South Texas Project Electric Generating Station P.O. Box 289 Wadsworth, Texas 77483

September 7, 2010
U7-C-STP-NRC-100199

South Texas Project
Units 3 and 4
Docket No. PROJ0772
Responses to Request for Additional Information

Reference: Letter from Tekia Govan to Mark McBurnett, "Request for Additional Information Re: South Texas Project Nuclear Operating Company Topical Report (TR) WCAP-17116-P Revision 0, Supplement 5 – Application to the Advanced Boiling Water Reactor" (TAC No. RG0012), June 7, 2010 (ML101580249)

Figure 2-1 – PCT for Different Feedwater Coast Down Times

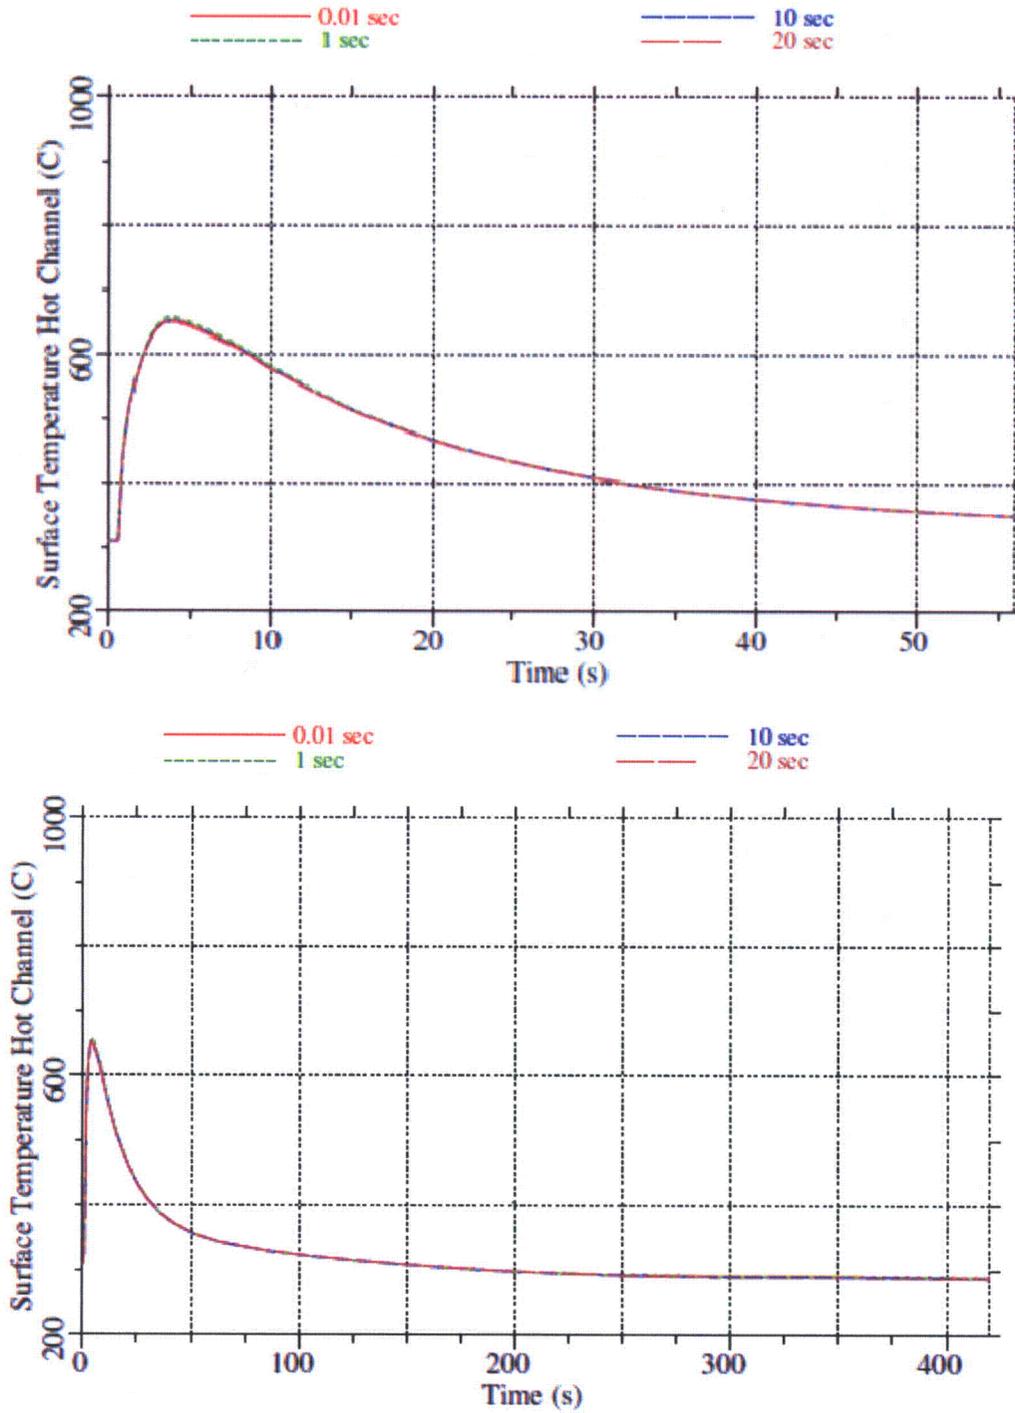
In Section 4.4.2 of WCAP-17116, fast steam line isolation is stated to be a conservative assumption because it reduces voiding in the core at the start of accident. Would this apply to feedwater as well, noting that figures-of-merit such as PCT in ABWR appear to be a function of very early formation and collapse of voids in the reactor coolant rather than long-term coolant inventory makeup? Demonstrate that the assumption of fast (1 s) feedwater coast down is conservative from the standpoint of PCT.

To investigate the effect of feedwater coastdown time on the calculated Peak Clad Temperature (PCT), additional GOBLIN runs were performed with feedwater coastdown times of 0.01, 10 and 20 seconds. These calculations showed no difference in the calculated PCT for hot or average channels when varying the assumed feedwater coastdown time. Because the PCT occurs so early in the accident sequence, continued flow from feedwater pumps is unlikely to have a significant effect on the PCT. Figure 2-1, below, shows clad temperature for the limiting elevation of the hot channel as a function of feedwater coastdown time. Note that the curves for the four coastdown times are superimposed on top of each other.

These calculations conclude that feedwater coastdown times that are longer than the fast (1s) coast down time do not have an effect on the PCT.

Figure 3-1 Variation of Maximum Cladding Temperature During Partial Core Uncovery with Respect to Bundle Peaking Factor

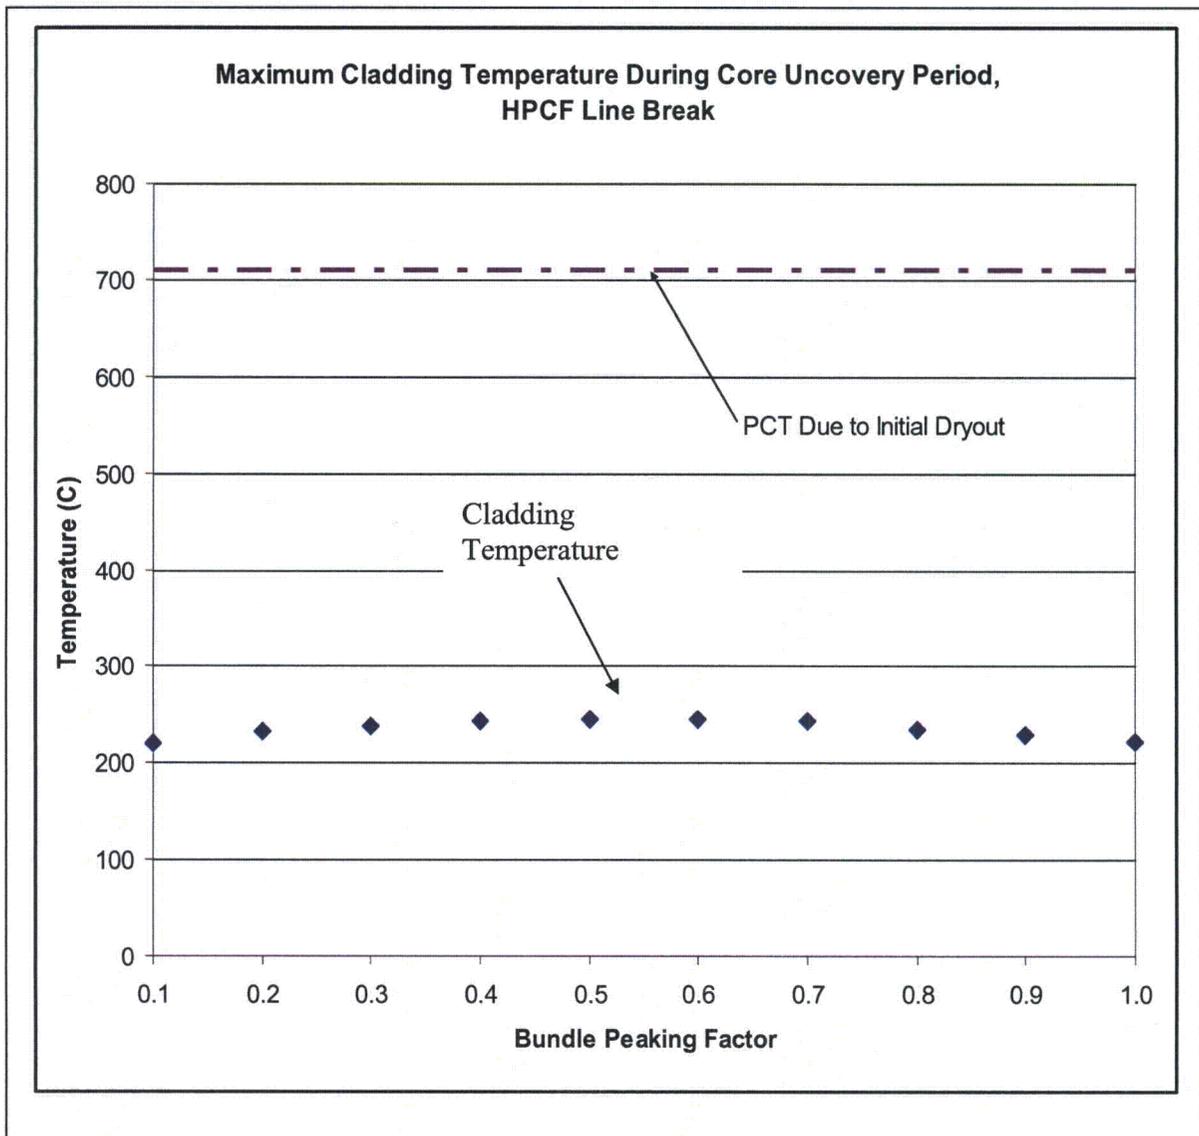
Section 4.5.1.2 of WCAP-17116 (HPCF break spectrum sensitivity cases) describes how prediction of core uncover is more likely in low-power assemblies than in high-power ones due to swelling of the two-phase mixture. In view of this, it is not intuitively obvious a priori which channel would be the most conservative one to consider (highest-power, lowest-power, or somewhere in between).

- a) Can you demonstrate that no assembly would experience PCT significantly higher than the ones documented in the sensitivity analysis (i.e., would explicit modeling of an intermediate lower-power assembly yield more conservative results)?
- b) What is the procedure for the identification of hottest channel?

- a) The bundle power peaking factor values for the High Pressure Core Flooder (HPCF) break bundle power sensitivity study of 0.3, 0.6, 0.9, 1.2, 1.5 and 1.7 are expanded to cover peaking factors ranging from 0.1 to 1.7, and a peaking factor resolution of 0.1 is used.

For each power level, the GOBLIN maximum cladding temperature during the core partial uncover period after the automatic depressurization system (ADS) is actuated, is shown in Figure 3-1. The GOBLIN peak cladding temperature (PCT) due to the initial dryout is also included for comparison purposes.

The results of the expanded study, as shown in Figure 3-1, show that the maximum cladding temperature during the partial uncover is well below the PCT during the initial early dryout time, and the maximum cladding temperature is also a well behaved function of bundle power. Figure 3-1 also shows that the maximum cladding temperatures for these additional assumed bundle peaking factors are not significantly higher than the ones documented in the sensitivity analysis in WCAP-17116-P. Therefore, explicit modeling of lower power assemblies is not warranted.

- b) Because the maximum cladding temperature during the partial core uncover is well below the PCT that occurs during the initial dryout due to the pump coastdown, the hottest channel is the one with the channel power described in Section 4.3.1.2 of WCAP-17116-P.

Figure 11-1 Break area for the RIP failure

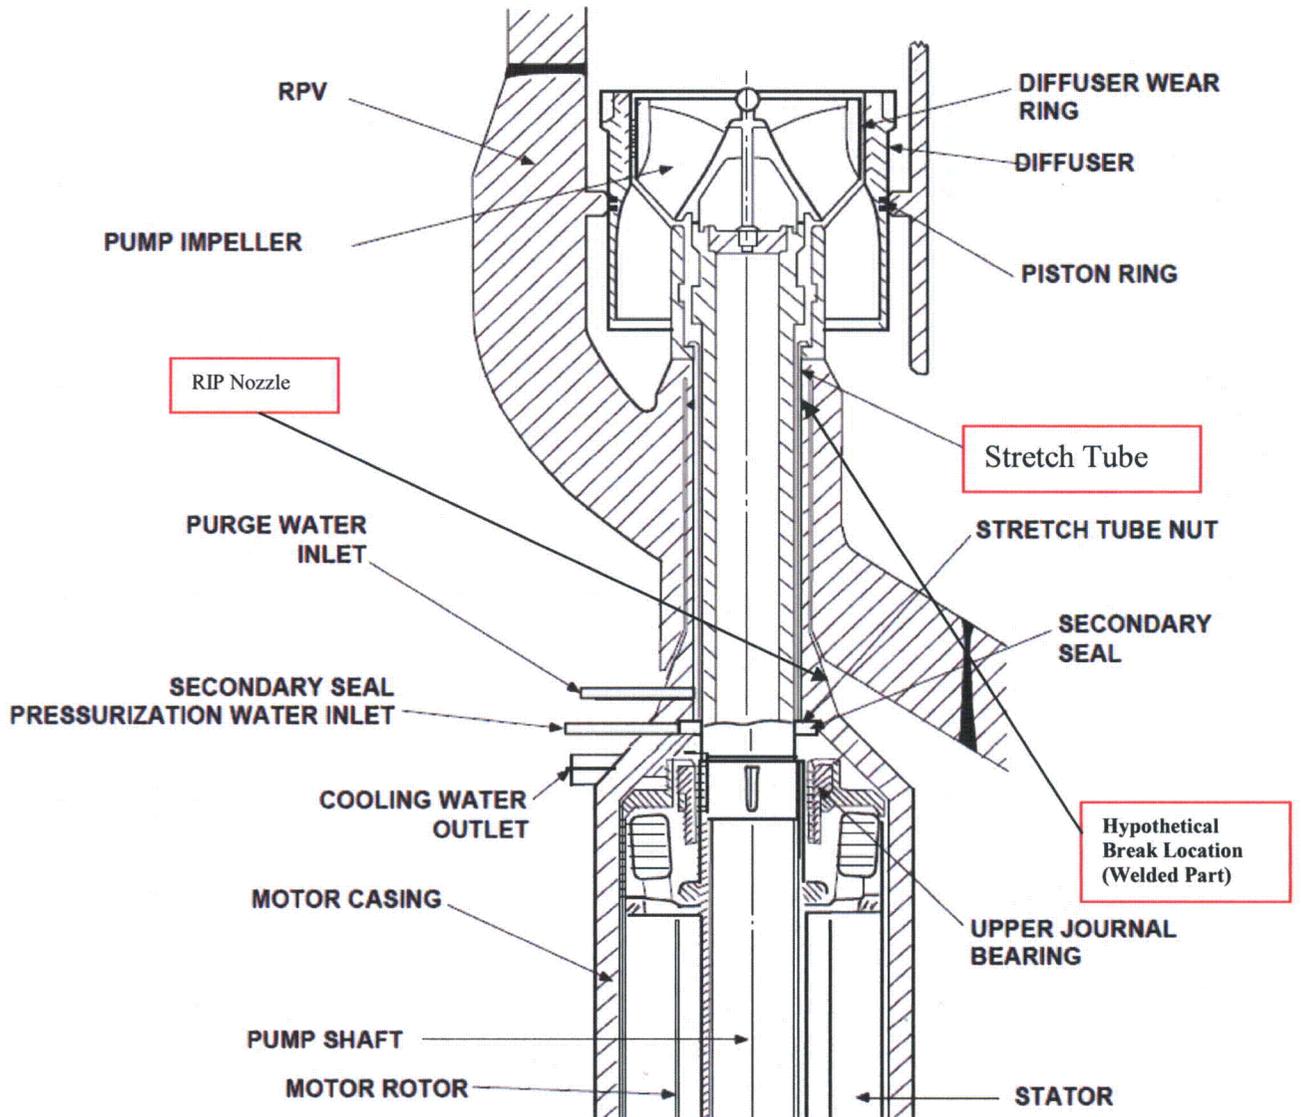
a) Discuss the transient response to a RIP failure LOCA.

b) Provide justification to support the ABWR DCD assumption that the break flow due to the RIP failure would be bounded by the break flow in BDLB accident scenario. What is the equivalent break flow area for the RIP failure?

A detailed justification, which supports the assumption that the break flow due to Reactor Internal Pump (RIP) failure is bounded by the design basis Bottom Drain Line Break (BDLB), is provided in ABWR DCD Tier 2 Subsection 15B.3.4.

The break area for the RIP failure, which is equivalent to a gap between the stretch tube and the RIP nozzle (See Figure 11-1), is less than the design basis BDLB area (20 cm²).

Figure 16-1 Integrated Heat Transfer from Steam Dome Structures to Coolant for FWLB3 case

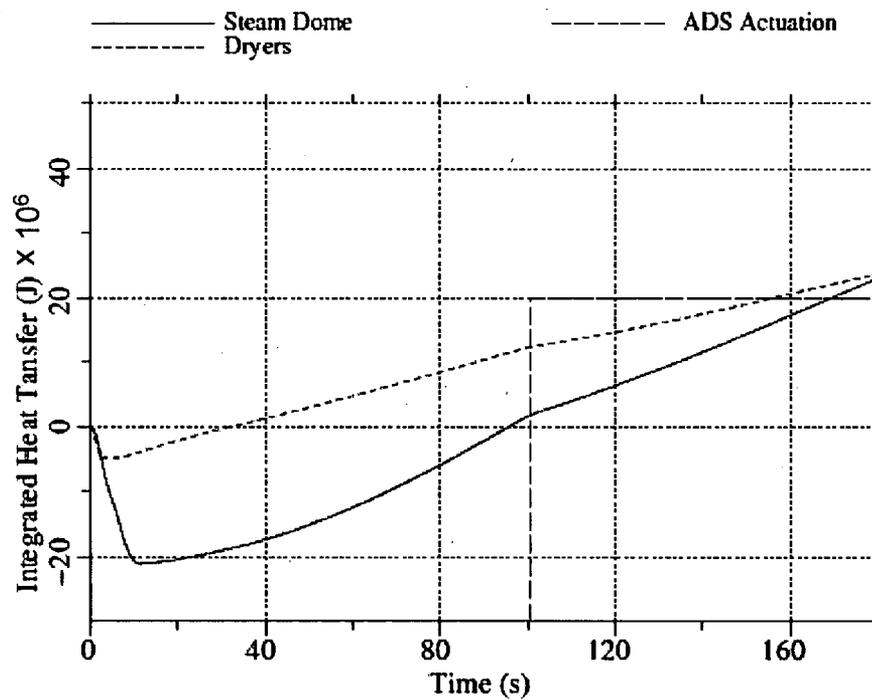
- a) Since the steam dome volume acts as a dead volume prior to ADS actuation, metal heat release to steam could increase the steam enthalpy above saturation. When ADS activates, the rate of system depressurization could be affected by the amount of energy removal. Describe the metal heat release to the dead volume and estimate the amount of heat released to steam prior to ADS actuation and the potential for superheated steam to be vented through the ADS.
- b) Is the volume and metal heat of the piping to the point where it is isolated from the reactor coolant system accounted in the ABWR ECCS Evaluation Model?

- a) Table 16-1 shows the heat transfer between the metal of the steam dome and the steam immediately before the Automatic Depressurization System (ADS) actuates for each of three breaks. Figures 16-1 through 16-3 include the same data, along with the time when the ADS valves open. The steam flowing to the ADS valves becomes superheated in all cases described below except for the feedwater line break.
